## Product Change Notification - KSRA-23LPHB699

CCB 3845 and 3845.001 Final Notice: Implement new packing material (non-bakeable tray) for selected products available in 100L and 64L TQFP (14x14x1mm) packages at MMT assembly site

Implement new packing material (non-bakeable tray) for selected Atmel products available in 100L and 64L TQFP (14x14x1mm) packages at MMT assembly site

**Result of Drop Test :**

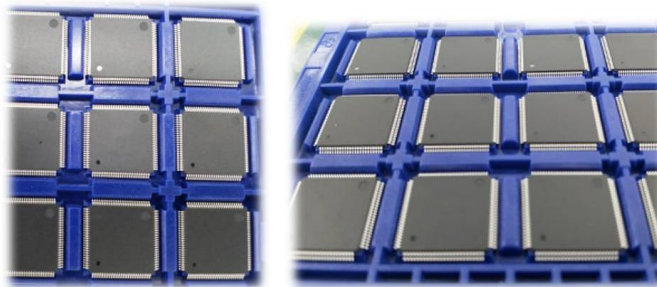
<b>Package</b>	<b>Drop height (m.)</b>	<b>Qty.</b>	<b>Result</b>
100 TQFP	1	10 tray / 900 units	Passed

- DROP TEST is Accept.
- Package have no defect.
- 100% Yield

**Functional Test :**

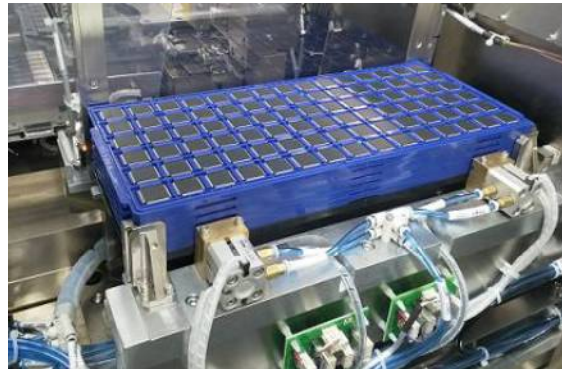
- *TRAY 100 TQFP 14X14 ,*
- *M/C # ASM model MPENIX*
- *Auto running 50 strips (1500 units)*

- FUNCTIONAL TEST** is Accept
- Machine don't jam.
- 100% yield, Have no defect
